UK-2673.0-1-26

PAV H 5 Bank Elevator Phase 1

ADDENDUM #04

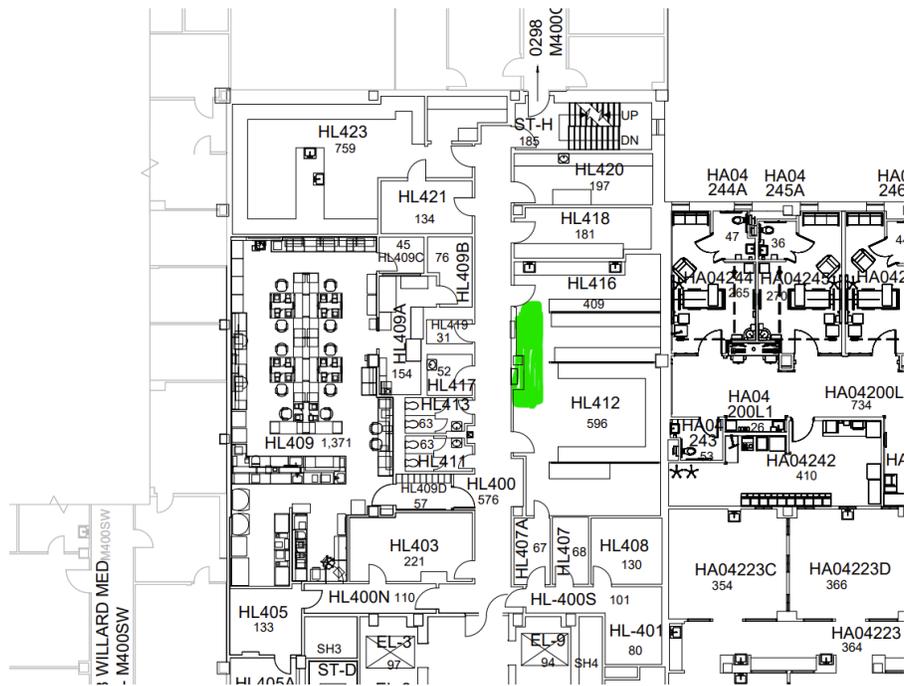
1. Refer to sheet P&FP1.0 – connect new oil smart sump pump to existing JACE panel located in room H14. Provide minimum of (6) conductors from pump to JACE panel for sump pump contacts. Provide all necessary wiring and connections per UK standards and coordinate work with UK controls team.
